**NAPERVILLE PLANNING AND ZONING COMMISSION  
COUNCIL CHAMBERS – MUNICIPAL CENTER  
FINAL AGENDA  
09/19/2012 - 7:00 p.m.**

3. PC Case # 12-1-084 Walmart (continued from August 22, 2012)

Request: Conduct the public hearing for a major change to a PUD,  
preliminary/final PUD & subdivision Plat, and associated variances  
and deviation to allow construction of a Walmart at the southeast  
corner of 75th Street and Beebe Drive.

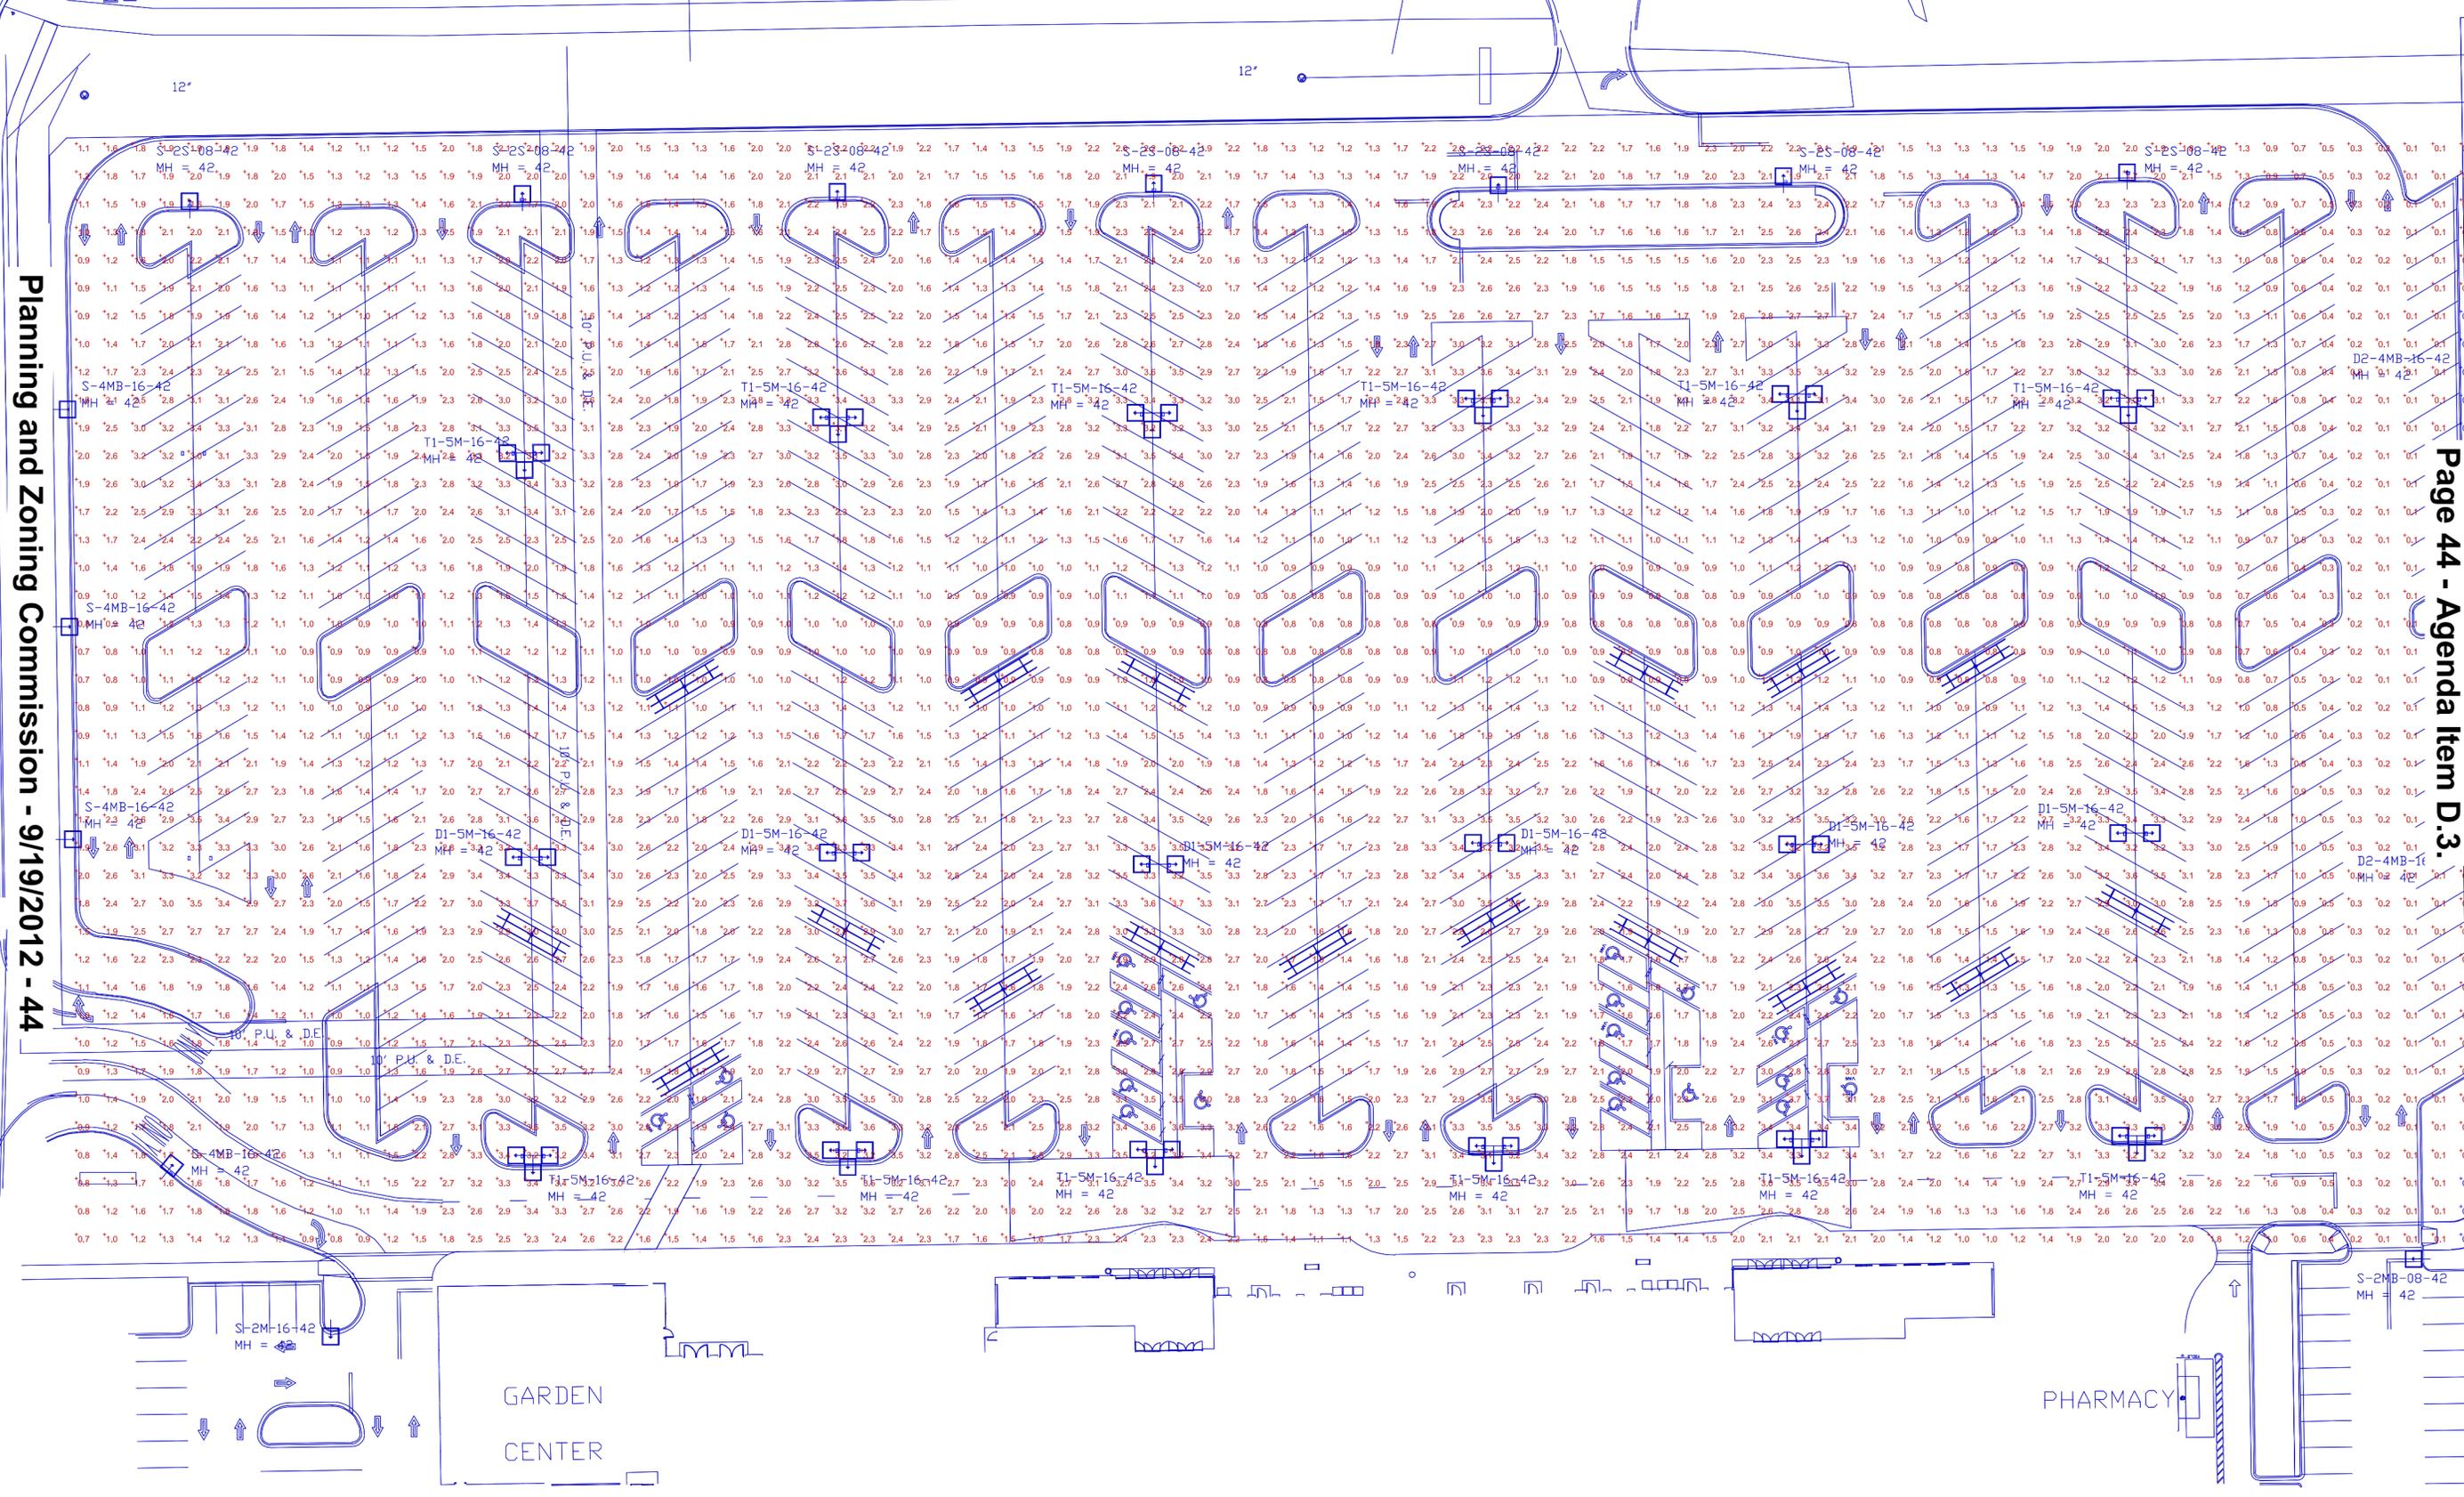
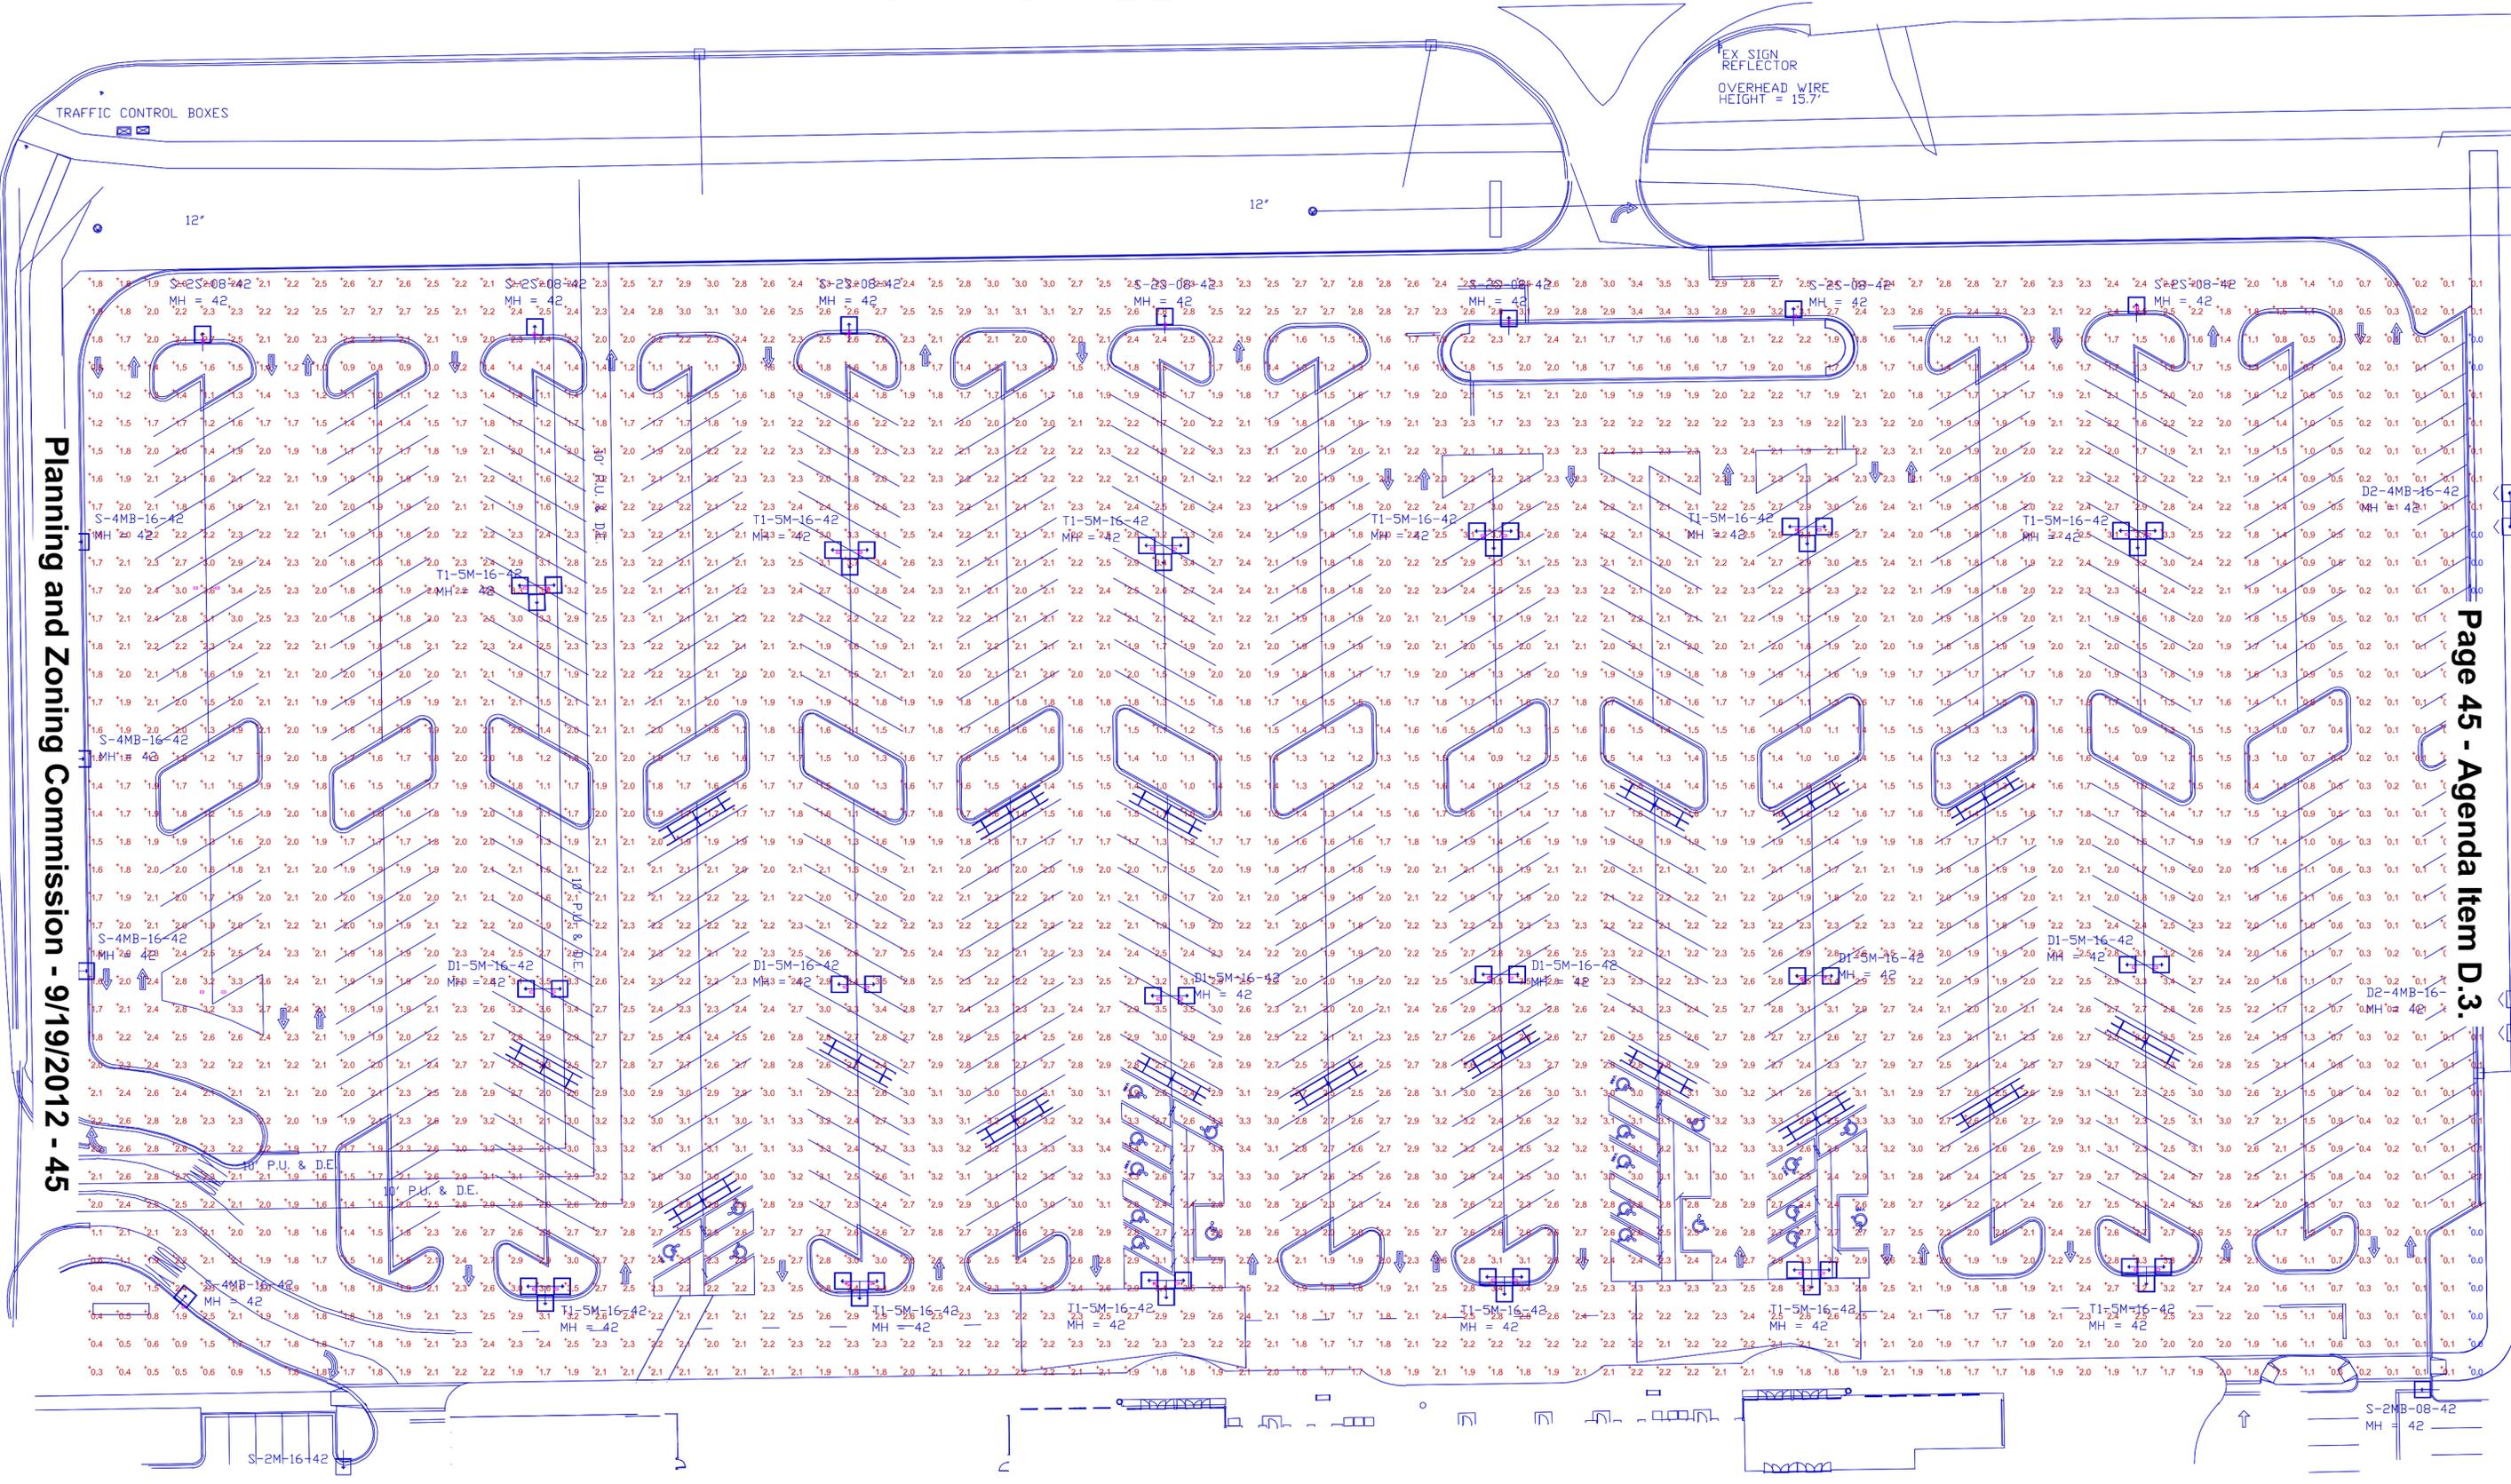
Staff had required a sightline drawing for the south entrance on Beebe Drive, and upon review, concurs with the recommendations of the petitioner to install a “Blind Entrance Ahead” sign on the approach to the entrance from both directions. These signs will be installed in addition to the existing signage on Beebe near the proposed entrance, which reads “Curve Ahead” and “15 mph”. Staff is of the opinion that the additional signage, in conjunction with the existing warning signage, is adequate to alert motorists of the potential traffic conflicts at this location.
